Access Compliance Report

Public Rights-of-Way

(Curb Ramps)

Intersection ID: 46807	Main Street: ADLIN_AV	Cross Street: SWEET_BING_CT	Location:	N
ADA ID: 18FB08D94489	Ramp Type: PerpDiag	Initial Pass/Fail: Fail	Overall Compliance: No	Severity Score: 21.25
Codes/Mitigation Info/Possible Solution		Field Measurements/Component Compliance

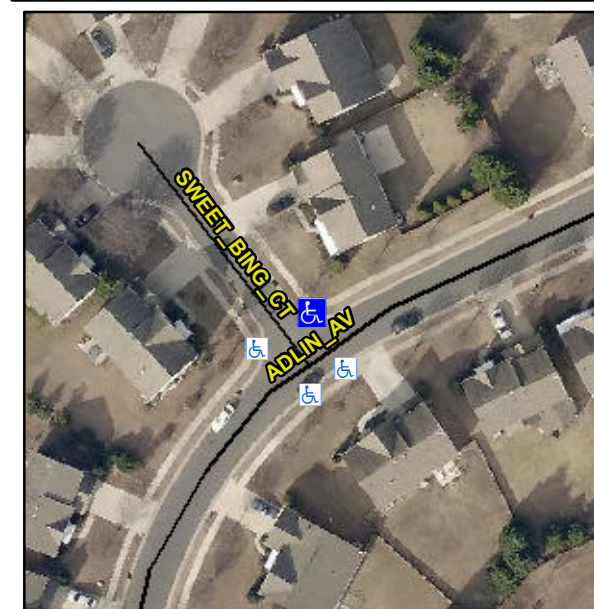
Not Found, R304.5.1, R304.2.2

Compliance	Description	Data	Compliance	Description	Data
N/A	Ramp Length (in)	48.5	No	Ramp Slope (%)	11.8
No	Ramp Width (in)	41.5	Yes	Ramp XSlope (%)	1.4
N/A	Flare Type LT	N/A	N/A	Flare Type RT	N/A
N/A	Flare Slope LT (%)	N/A	N/A	Flare Slope RT (%)	N/A
N/A	Flare Traversable LT?	N/A	N/A	Flare Traversable RT?	N/A
N/A	Landing Length (in)	N/A	N/A	DWS Provided?	N/A
N/A	Landing Width (in)	N/A	N/A	DWS Contrast?	N/A
N/A	Landing Slope (%)	N/A	N/A	DWS Length (in)	N/A
N/A	Landing X Slope (%)	N/A	N/A	DWS Full Width?	N/A
N/A	Landing Curb? (Y/N)	N/A	N/A	DWS Offset (in)	N/A
N/A	Shared Landing?	N/A			
N/A	Gutter Ponding?	N/A	N/A	Gutter Slope (%)	N/A
N/A	Gutter Lip Ht (in)	N/A	N/A	Gutter X Slope (%)	N/A
N/A	Painted X Walk1?	No	N/A	Painted X Walk2?	No
	X Walk 1 Direction	To SW		X Walk 2 Direction	To SE
N/A	X Walk 1 Width (in)	N/A	N/A	X Walk 2 Width (in)	N/A
	X Walk 1 Slope (%)	2.2		X Walk 2 Slope (%)	0.4
	X Walk 1 X Slope (%)	0.8		X Walk 2 X Slope (%)	1.7

Remove & Replace Curb Ramp With Two New Directional Ramps or Equivalent.
